Attention:	Tim Bailey, Project Manager
Company:	Z Energy
Date:	23 March 2020
From:	Jane Rennie, Urban Designer / Senior Principal / CPTED Practitioner
Message Ref:	Z Energy Rolleston – Urban Design Assessment
Project No:	C18173

The Council have issued a RfI and the purpose of this Memorandum is to outline the urban design related response.

Z Rolleston RC205094 Selwyn RFI- Traffic Response

**RESPONSE TO RFI – Z ENERGY SERVICE STATION, ROLLESTON**

Figure 1: Exert of Drawing Z\_PS\_A09 – Proposed External Elevations – Stone Wall, Seating Area and ‘Swap N Go’ Cage along Southern Elevation of Retail Store

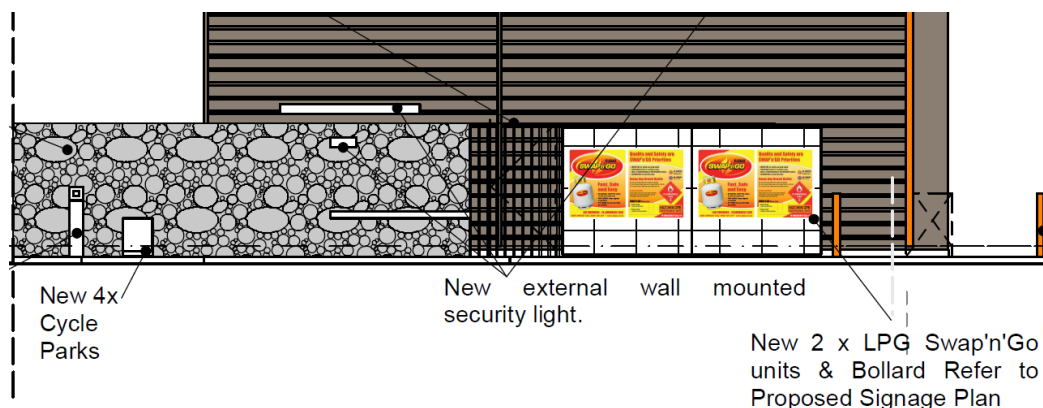
*It is noted that the proposed shop does not include an active frontage to Brookside Road, rather this elevation is dominated by a storage unit and extensive signage. The provision of active frontage to Brookside Road would have provided a continuation of the existing built form in the vicinity and enabled a form of private-public surveillance and interface.*

*As a minimum we would need to see the office space, which is facing Brookside Road, to have a window at no higher than 1.20m on its southern façade installed. This window would have to be kept free of any obstruction, including artwork or advertising. A window in this location would allow for some active passive surveillance as in ‘eyes on the street’ and would contribute to an active frontage.”*

*Please provide comment on providing an active frontage to Brookside Road.*

It is important to clarify the reference to ‘extensive’ signage along the southern retail elevation. As per **Figure 1**, 2x LPG ‘Swap N Go’ cages are proposed. These include panel artwork explaining how this service works and outlines relevant Health and Safety considerations. Each panel is 1.650m wide and as such is not considered to be ‘extensive’. Visually the scale and size of the signage will have not materially impact the residential properties’ opposite. Furthermore, the reference to “large scale service station signage having been placed on Brookside Road” is factually incorrect. The only signage proposed along this frontage is for traffic direction purposes and can hardly be described as “large scale”. The carwash sign on the northern side of the carwash faces into the site and will not be visible from Brookside Road.

encl: Figure 1 - Z Brookside Road  
AECOM letter dated 24 January 2020 - NES Consent Review  
cc: Karen Blair (4Sight Consulting);  
Neil Moon (Z Energy Limited)

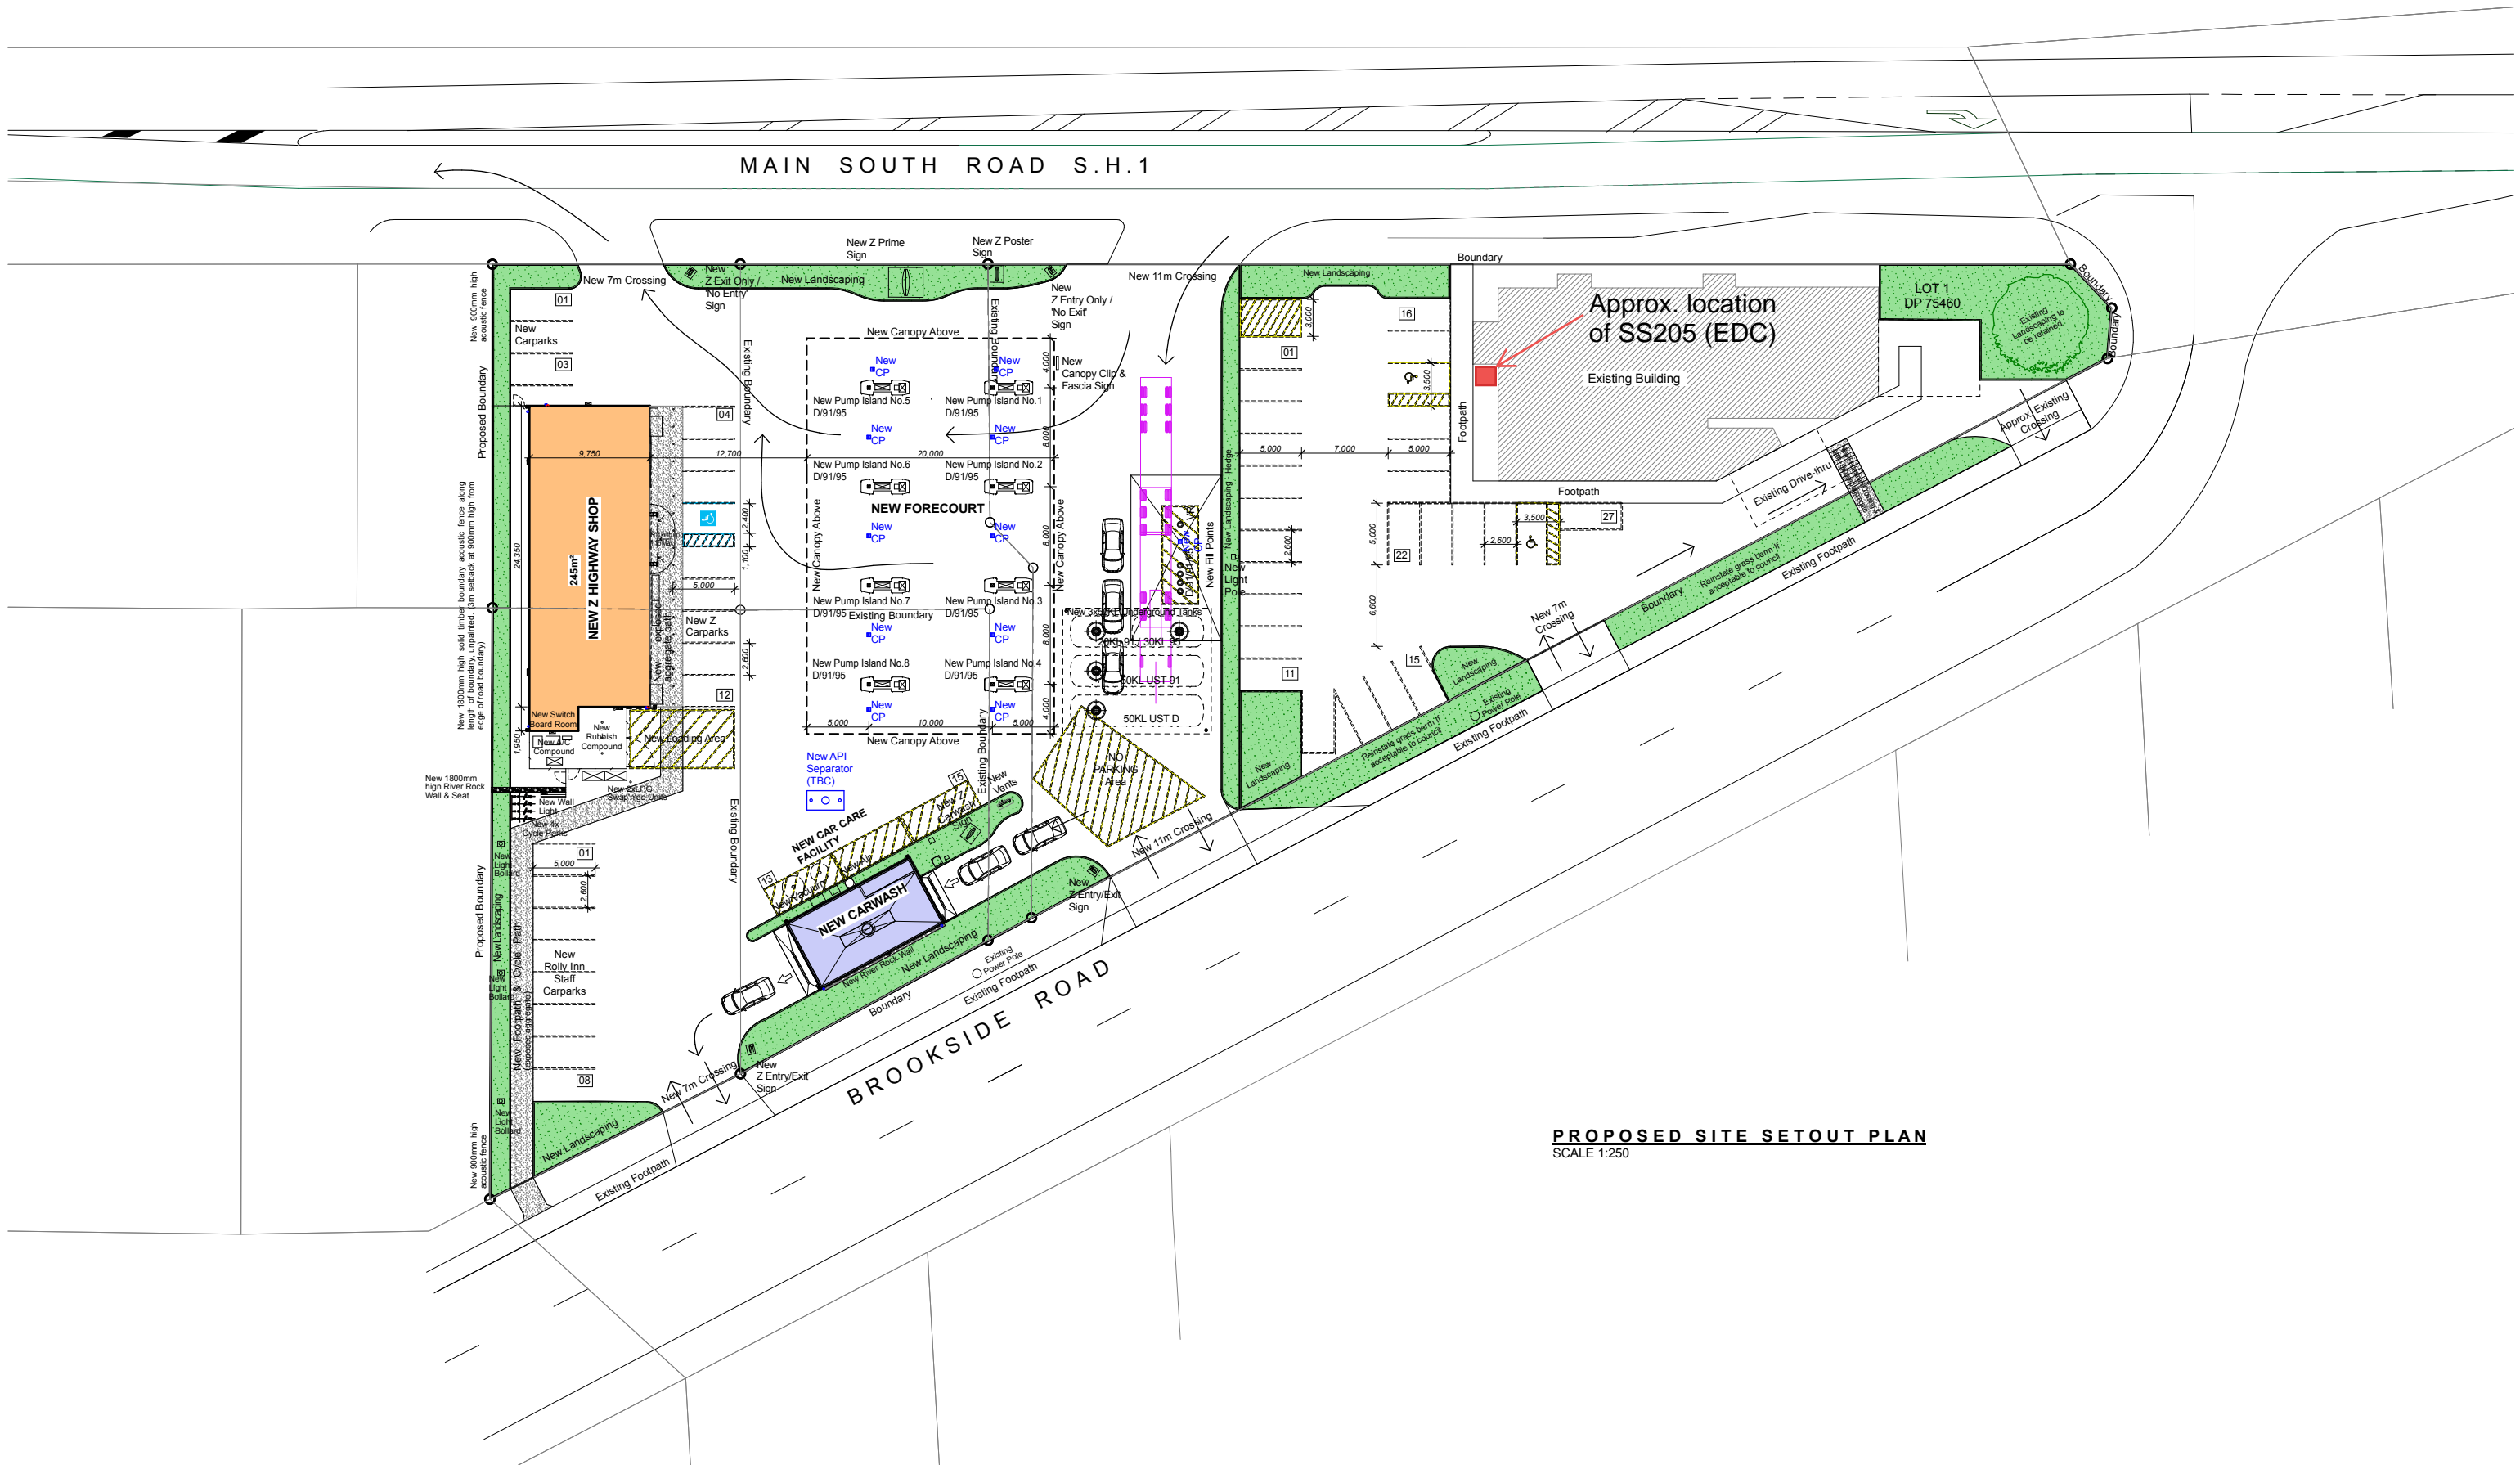
*Point 15 – “It is noted that the AECOM report states that the existing “hotspot” will be outside the area of disturbance, however the plans indicate that the area is likely to be disturbed. Please provide comment.”*

*Point 16 – “Please note that if the area is to be disturbed, I consider that the NES would apply. The soil in the hotspot area does need to be dealt with appropriately. Because lead concentrations in this area exceed the commercial/industrial guidelines the disturbance would most likely be a restricted discretionary activity. Depending on the plans for dealing with the hotspot, either a management plan or validation report should be provided detailing what works took place to manage, or remove the hotspot.”*

Please refer to the attached plans (**Figure 1**) which shows the location of sample 205 SS.

Although the land in the vicinity of sample 205 SS is planned to be disturbed as part of the development, we do not consider that the NES applies.

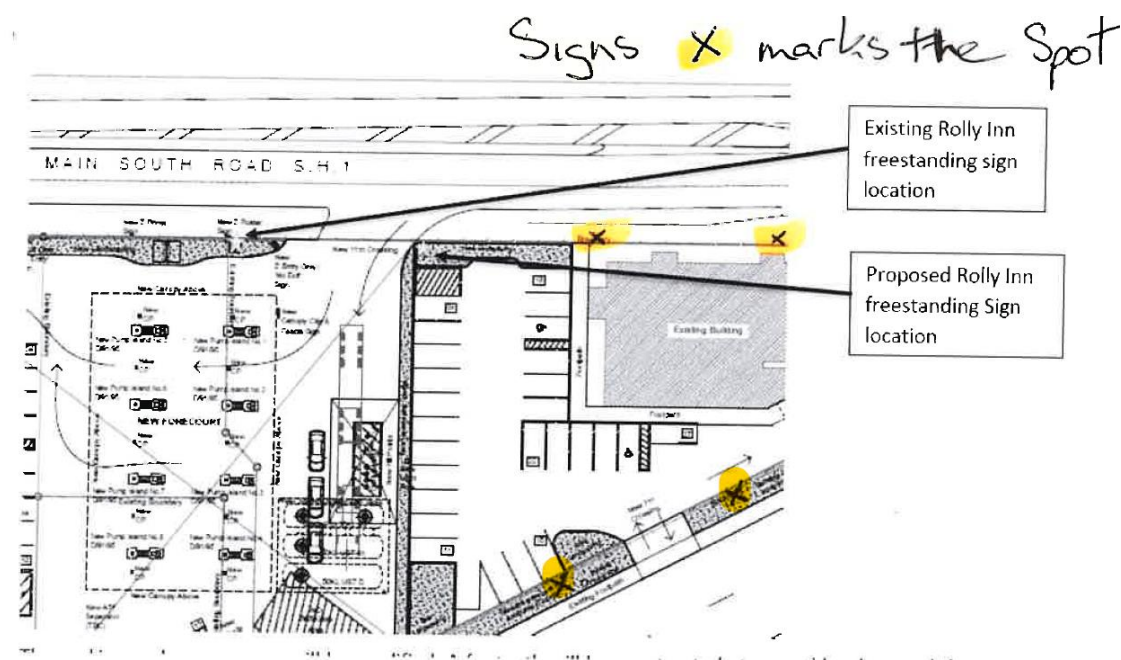
- 1. Please provide comment on providing an active frontage to Brookside Road*

The mitigation proposed, in particular the rock wall and seating arrangement, is considered appropriate because:

- The path has a clearly identifiable entrance point. The layout and design of service stations are well recognised by the general public. It will be quite apparent to users of the path that it extends into the broader service station site and will provide access to the shop. To that end, no one using it will perceive it as a “path to no-where”.

- The area is pleasant and visually attractive and comprises a number of elements providing visual interest and depth and reinforcing an appropriate and human scale. This type of landscape treatment is entirely appropriately within residential environments (whilst it may not be so in a typical commercial environment).

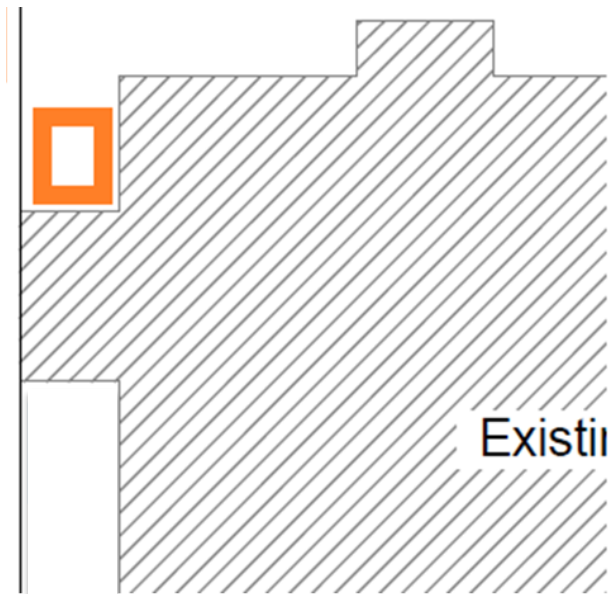
11. *The assessment of the cycle parking non-compliance at the Rolly Inn indicates there is no change in activity, whereas the application includes a function centre that is not currently at the site. Please provide commentary on the potential additional cycle demand associated with functions and whether there is a need for additional cycle parking.*

With regards to cycle parking for the Rolly Inn, Section 5.1 of the AEE identifies that no cycle parking is proposed at the Rolly Inn and acknowledges that this triggers the requirement for discretionary activity consent pursuant to Rule 5.5.1.7. As such, consent is sought on the basis that, inter alia, no cycle parking is provided for the Rolly Inn. That said, cycle parking can be provided, and the two bicycle rails can be located as follows (refer to the orange square in the plan excerpt below):

The shared space next to the disabled space would provide a sufficient gap for cyclists to be able to access the area and there is enough space there to accommodate the necessary dimensions. We confirm that we have checked with Andrew Leckie (Stantec) regarding this location and he has confirmed it as being appropriate from a traffic point of view.
